# UNITED STATES PATENT AND TRADEMARK OFFICE

APPLICATION NO.	FILING DATE	FIRST NAMED INVENTOR	ATTORNEY DOCKET NO.	CONFIRMATION NO.
10/604,693	08/11/2003	Perry Wade Schoneboom	23077-00002	1692

This is the second office action for application number 10/604,693, Support Bracket, filed on August 11, 2003.

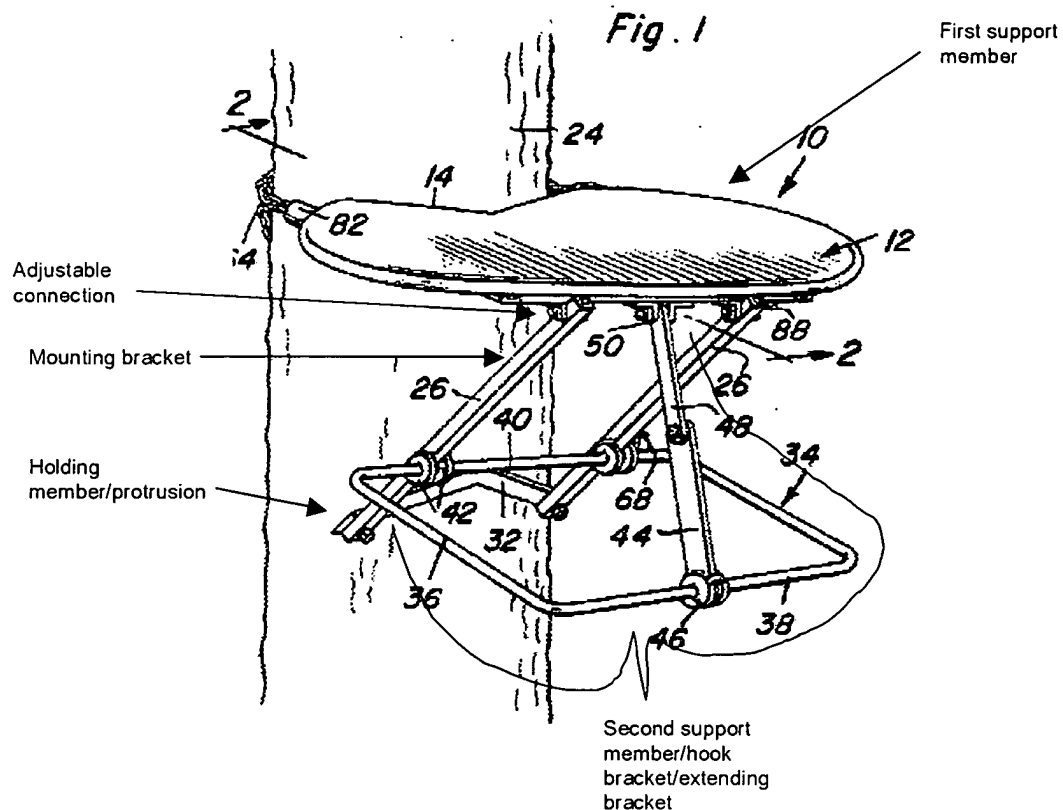
Claims 1, 2, 6-8, 10, 11, 15 and 16 are rejected under 35 U.S.C. 102(b) as being anticipated by U.S. Patent number 3,513,940 to Ussery.

Ussery '940 discloses a bracket assembly (above) comprising at least one mounting bracket (above), and a supporting member connected to the mounting bracket, wherein the supporting member includes a first and second support member (above), wherein the mounting bracket is adjustably connected to the supporting member (above), wherein a hook bracket (above; a "hook" is a "curved device for holding" according to Merriam Webster's Collegiate Dictionary - 10<sup>th</sup> Edition, so clearly, each of the curved ends of 44 and 48 is considered a "hook" and thus this is a hook bracket) connects the mounting bracket to the supporting member, wherein the hook member is adjustably connected to the mounting bracket (near 42), wherein the mounting bracket is inherently forced against an object (24) when an item is hung from

the supporting member, wherein the supporting member includes at least one extending bracket (above) connected to the mounting bracket, wherein the mounting bracket includes a holding member/protrusion (above).

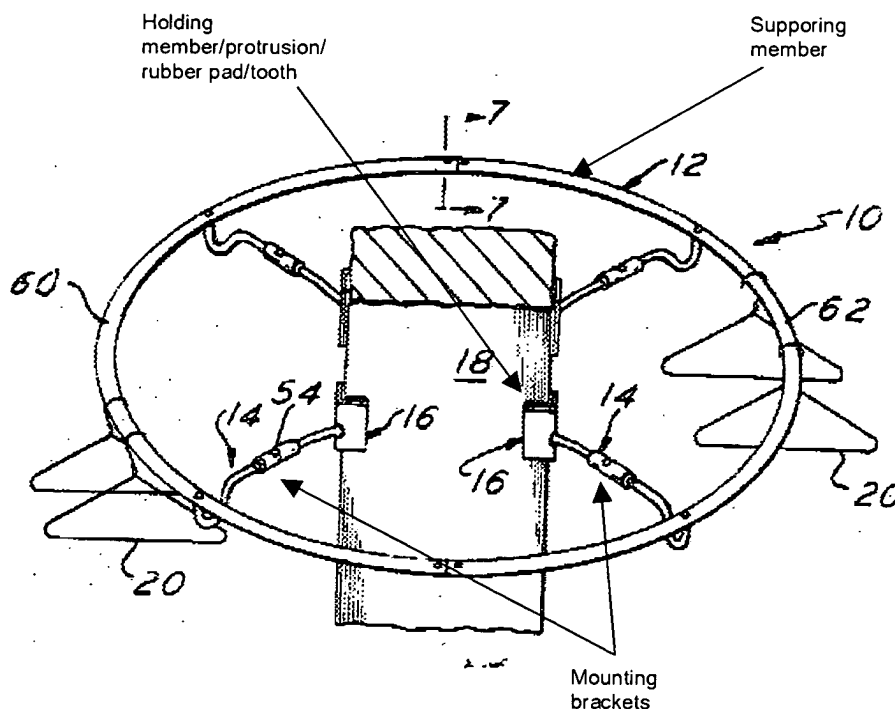
Claims 1, 15-17, 26, 27 and 29-31 are rejected under 35 U.S.C. 102(b) as being anticipated by U.S. Patent number 3,613,896 to Miller, Jr.

Regarding claims 1 and 15-17, Miller, Jr. '896 discloses a bracket assembly (above) comprising at least one mounting bracket (above), and a supporting member (above) connected to the mounting bracket, wherein the mounting bracket includes a holding member/protrusion/rubber pad (above, see column 2, line 56).

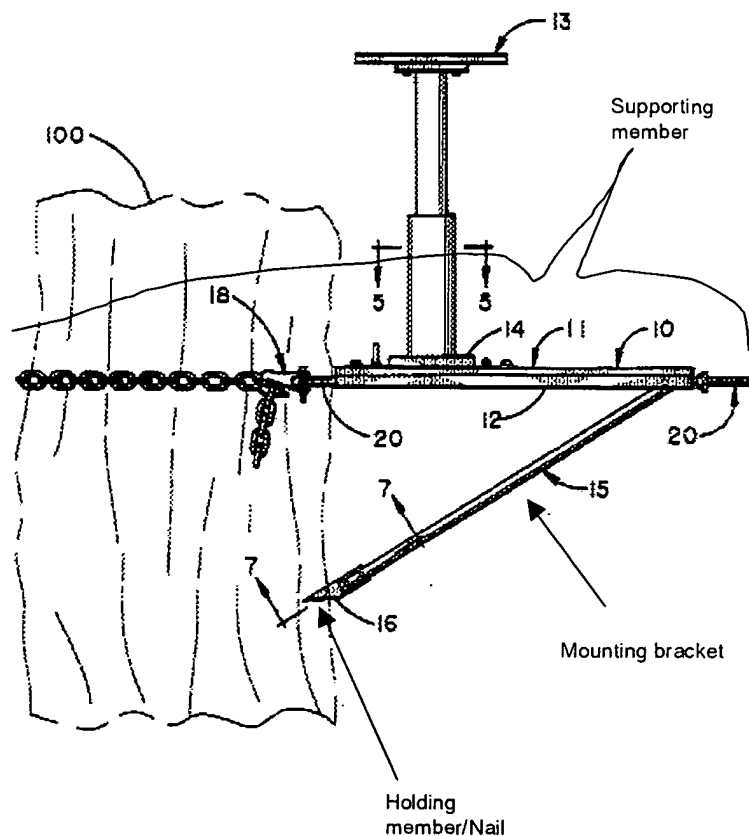
With respect to claims 26, 27 and 29-31, Miller, Jr. '896 discloses a bracket assembly (above) comprising a supporting member and a plurality of mounting brackets (above) adjustably connected (see figure 6, mounting member must be adjusted to

remove from or insert into supporting member) to the supporting member, wherein the supporting member is inherently positioned at a horizontal distance around an object, wherein the mounting brackets are inherently configured to support hanging items, wherein the plurality of mounting brackets are inherently forced against the object when an item is hung from the bracket assembly, wherein the mounting brackets include a tooth (above).
